MECKLENBURG COUNTY
HEALTH DEPARTMENT

APPLICATION FOR A RESIDENTIAL SITE IMPROVEMENT PERMIT/ CONSTRUCTION AUTHORIZATION FOR AN ON-SITE WASTEWATER SYSTEM, NEW WELL INSTALLATION, OR REPAIR OF EXISTING WELL

Re: Application for improvement permit for: 5 Bedroom House
Property Location: Ewart Rd, Huntersville, NC (PID 019-251-20)
Health Department File Number: **10315B (App ID 10471)**

SOIL/SITE EVALUATION
for ON-SITE WASTEWATER SYSTEM

PROPOSED PLOT PLAN

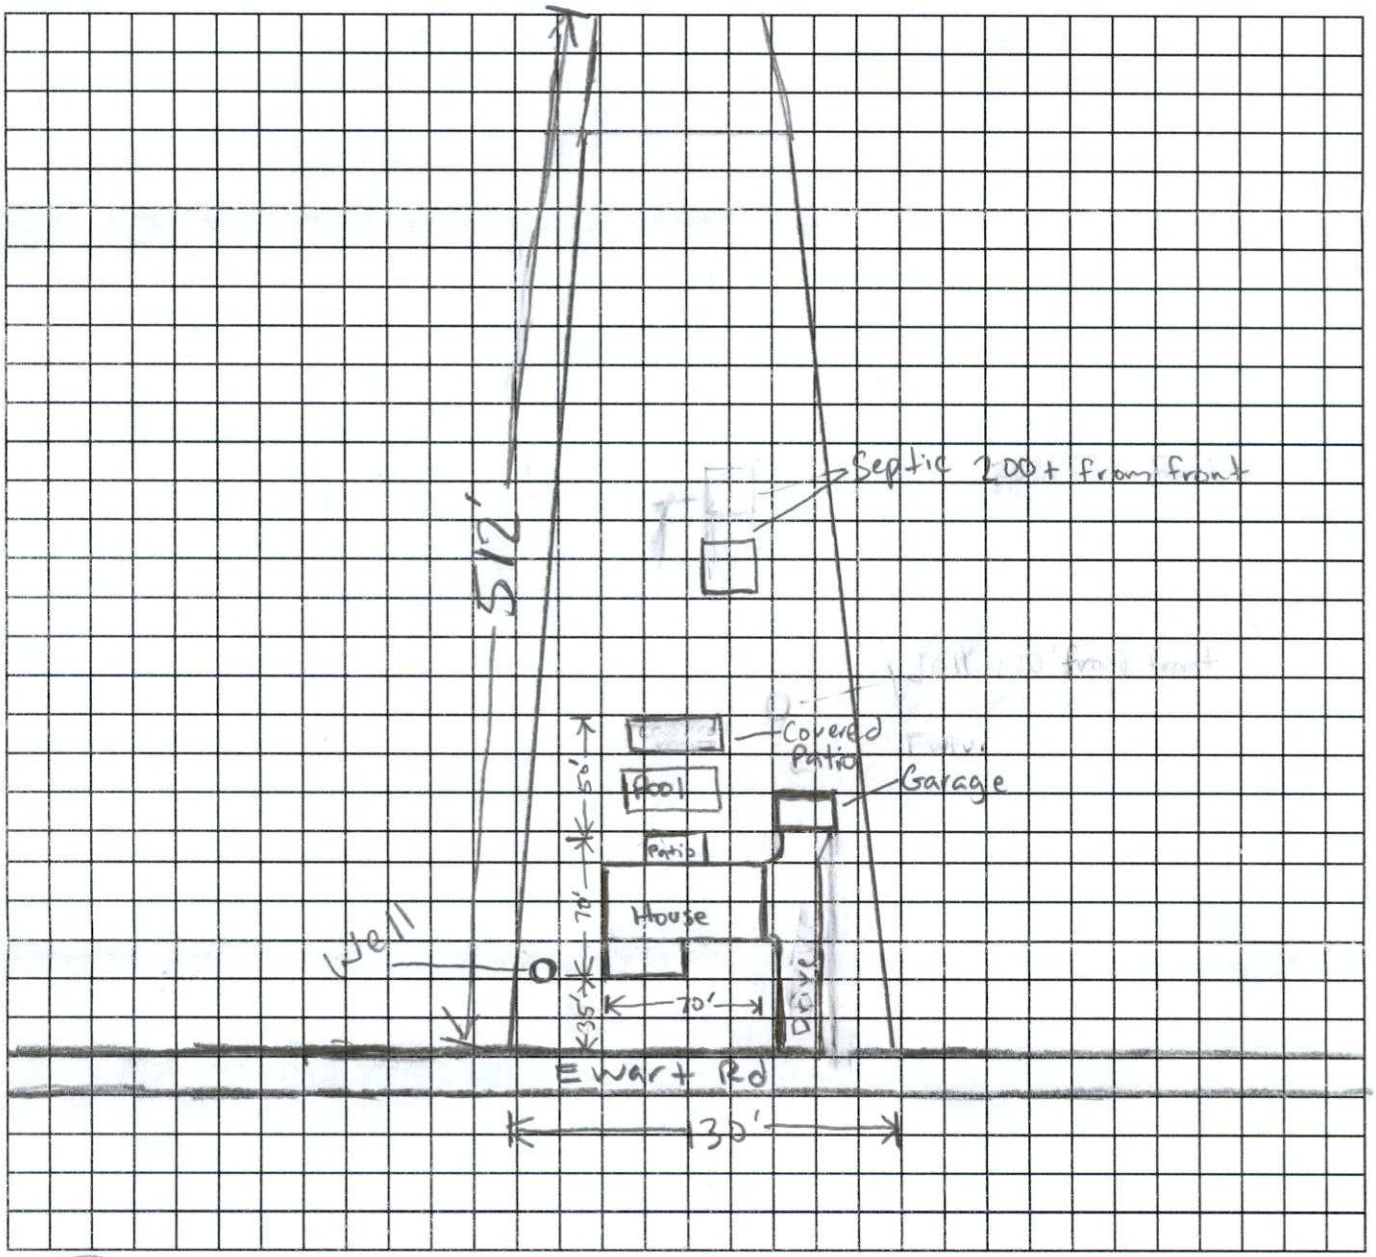
The Mecklenburg County Health Department, Environmental Health Division on June 14th, 2019 evaluated the above-referenced property at the site designated on the site plan that accompanied your improvement permit application. According to your application the site is to serve a 5 bedroom house, with a daily design flow of 600 gallons per day. The evaluation was done in accordance with the laws and rules governing wastewater systems in North Carolina General Statute 130A-333 and related statutes and Title 15A, Subchapter 18A, of the North Carolina Administrative Code, Rule .l900 and related rules.

Sketch of Soil Evaluation Locations

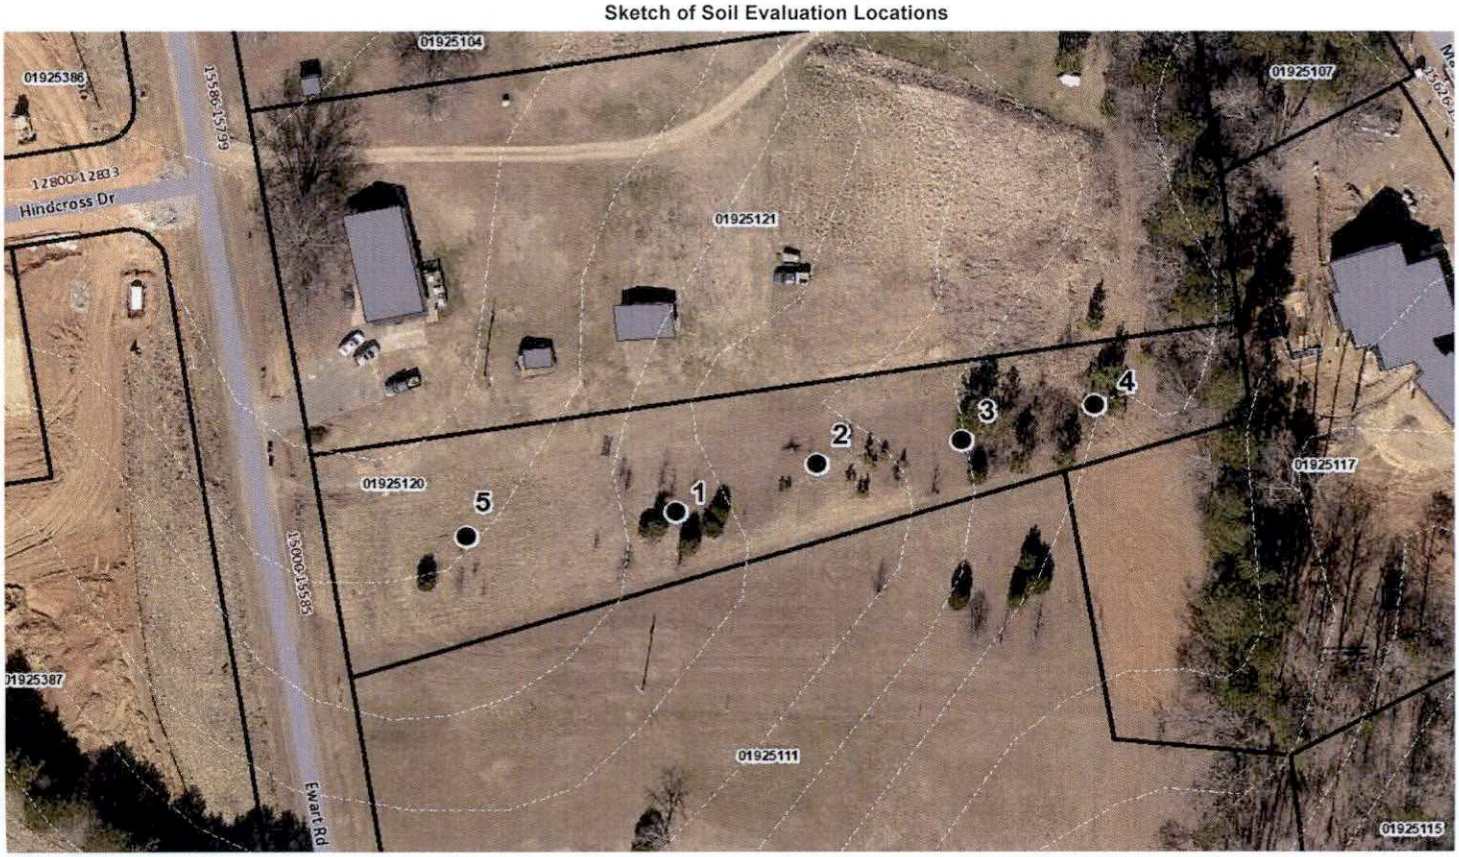
Based on the criteria set out in Title 15A, Subchapter 18A, of the North Carolina Administrative Code, Rules .1940 through .1948, the evaluation indicated that the site is **UNSUITABLE** for a ground absorption sewage system. Therefore, your request for an improvement permit is **DENIED.** A copy of the site evaluation is enclosed. The site is unsuitable based on the following:

- ☐ Unsuitable soil topography and/or landscape position (Rule .1940)
- ☒ Unsuitable soil characteristics (structure or clay mineralogy) (Rule .1941)
- ☒ Unsuitable soil wetness condition (Rule .1942)
- ☐ Unsuitable soil depth (Rule .1943)
- ☐ Presence of restrictive horizon (Rule .1944)
- ☒ Insufficient space for septic system and repair area (Rule .1945)
- ☐ Unsuitable for meeting required setbacks (Rule .1950)
- ☐ Other (Rule .1946)

PROFILE #	.1940 Landscape Position/ Slope%	Horizon Depth (IN.)	SOIL MORPHOLOGY .1941 .1941 Structure/ Texture	.1941 Consistence Mineralogy	b PROFILE FACTORS .1942 Soil Wetness/ Color	.1943 Soil Depth (IN.)	.1956 Sapro Class	.1944 Restr Horiz	General Comments	Profile Class & LTAR	Maximum Trench Bottom Depth for 3' Wide Conventional Trench
Boring #1	LS 3%	0 - 12	gr SL	SS SP FR SEXP							
		12 - 22	sbk SC	S P FR SEXP	2.5Y 6/1	30	NA	NA		US	NA
		22 - 30	mass C	S VP VFI EXP	at 22"						
Boring #2	LS 4%	0 - 4	gr SCL	SS SP FR SEXP							
		4 - 12	sbk SCL	SS SP FR SEXP	2.5Y -7/1	26	NA	NA		US	NA
		12 - 26	sbk C	S VP VFI EXP	at 22"						
Boring #3	LS 5%	0 - 12	gr SL	SS SP FR SEXP							
		12 - 29	sbk C	S P FI SEXP	2.5Y 7/2	29	NA	NA		PS IV 0.2	15" Need Cover
		29 - 38	mass CL	S P FR SEXP	at 29"						
Boring #4	LS 5%	0 - 12	gr SCL	SS SP FR SEXP							
		12 - 26	sbk C	S P FI SEXP	>32"	26	NA	NA		PS IV 0.2	12" Need Cover

26 - 32	Saprolite/Soil	Need pit							
Boring #5	LS 3%	0 - 10	gr/sbk SCL	SS SP FR SEXP							
		10 - 24	mass C	SS VP VFI EXP	>24"	24	NA	NA	saprolite inclusions 18 - 24"	US	NA

Description	Initial System	Repair System
Available Space (.1945)	US	US
System Type(s)	NA	NA
Site LTAR (gpd/sq ft)	**0.2**	**0.2**

Other Factors (.1946):
Soil Evaluation By: Jacob Presley, REHS, LSS
Others Present:
Site Classification (.1948): Unsuitable
Site Evaluation By: Jacob Presley, REHS, LSS
Others Present:

The site evaluation included consideration of possible site modifications, and modified, innovative or alternative systems. However, the Health Department has determined that none of the above options will overcome the severe conditions on this site. A possible option might be a system designed to dispose of sewage to another area of suitable soil or off-site to additional property.

However, the site classified as **UNSUITABLE** may be classified as **PROVISIONALLY SUITABLE** if written documentation is provided that meets the requirements of Rule .1948(d). A copy of this rule is enclosed. You may hire a consultant to assist you if you wish to try to develop a plan under which your site could be reclassified as **PROVISIONALLY SUITABLE.**
